February 13, 2013

RE: Casa Palma Apartment Development – 6112 SR 7, 33073

3 LEFT SIDE ELEVATION  
SCALE: 1/8" = 1'-0"

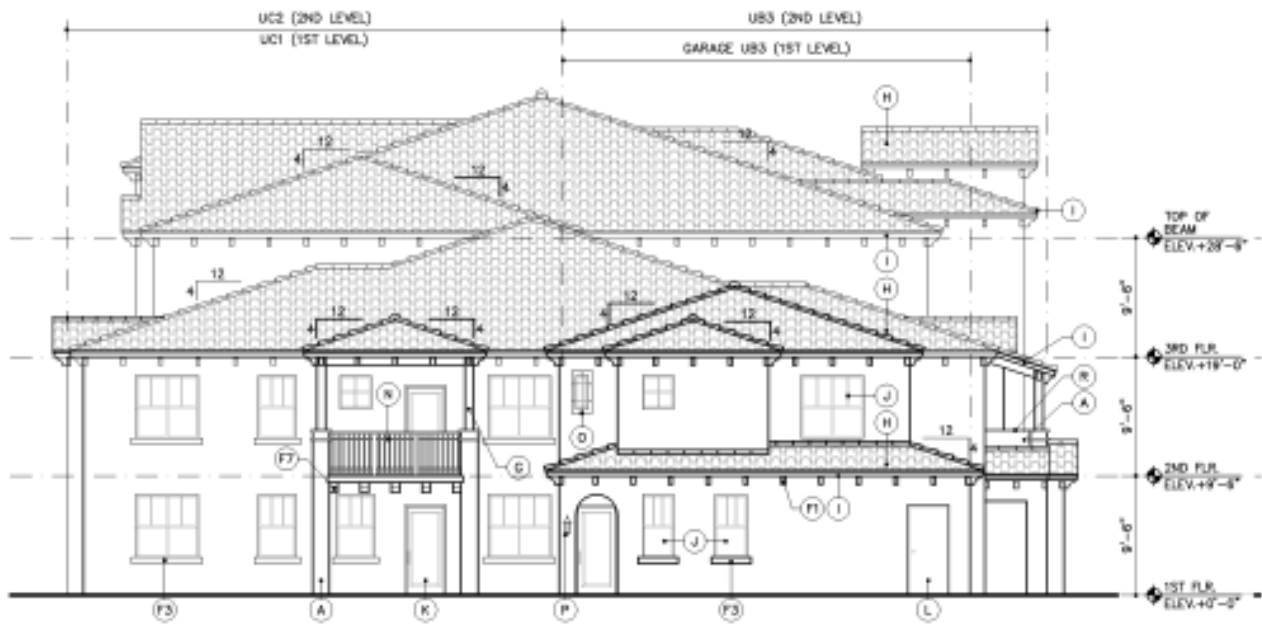
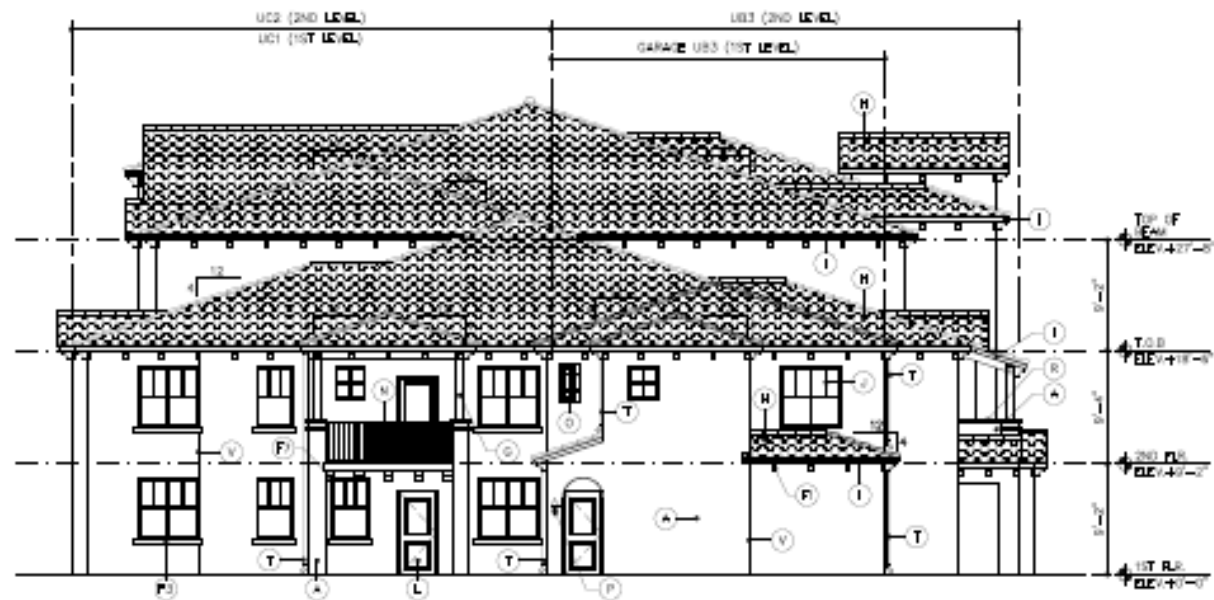
On October 24, during our second pre-permit plan review, Heidi Solano commented (Type III, permit # 12001687–12001689) that the “Left building elevation shown on sheet A3.3.1 is inconsistent with previously approved building elevation. Windows have been removed from the plans. Revise to match previously approved elevation”. In response to this comment, I spoke with Heidi on the telephone to discuss our reasoning behind the proposed change, as well as our concerns with the windows as previously drawn.

The windows previously shown in elevation occur on the outside of a vehicular garage. After much deliberation by ownership and management, it was concluded that it would be best to delete these, as they would otherwise be unsightly. We initially considered addressing the unsightliness (looking into a garage) with additional landscaping, but this alone could then present a potential security hazard, by offering a shielded, easy access point to ground floor, unoccupied space.

Following our discussion, Heidi and I were in agreement that the windows did not offer any meaningful value to the residential units, and could in fact become a security hazard, and recommended that I submit a memo for file. As such, we would like to request this amendment, and record it with this memorandum summarizing same.
